Open Issues for Cleanup

Verilog-AMS

Revision: 0.9

Date : 1/22/2001
Author : Jon Sanders
Project ID: VerilogAMS LRM 2.0

28.Section 9 : Which solver starts first?

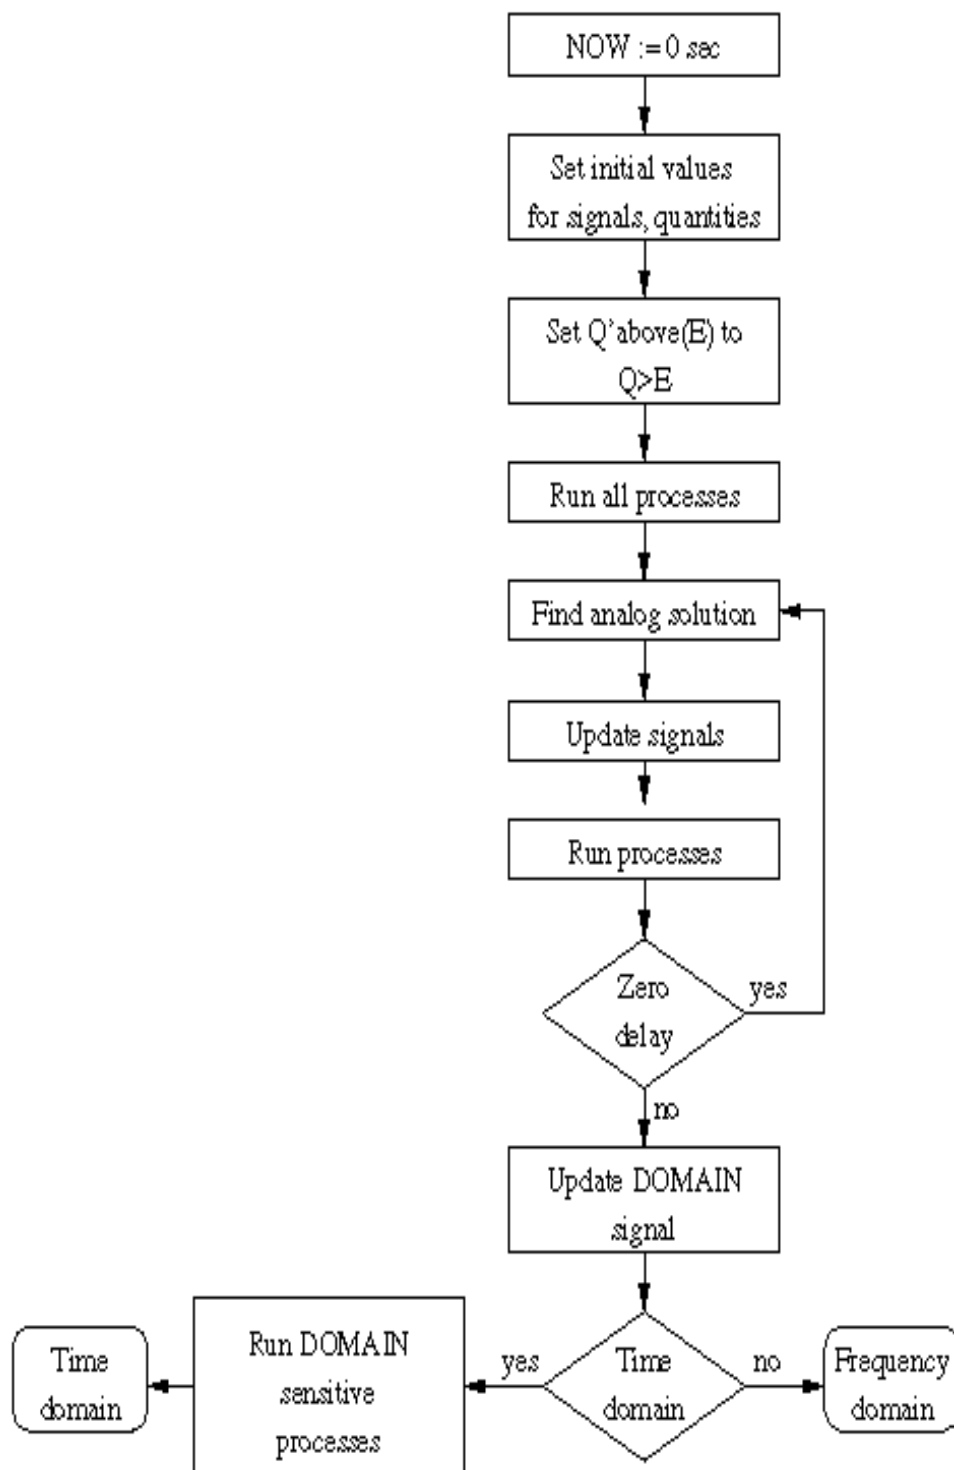
Initialization sequence of the simulation should be described - does the digital kernel or the analog kernel go first?

Recommendation: Specify that digital start first as part of the VHDL-AMS sync effort. Needed for simulator commands at time zero as well as mixed language simulators
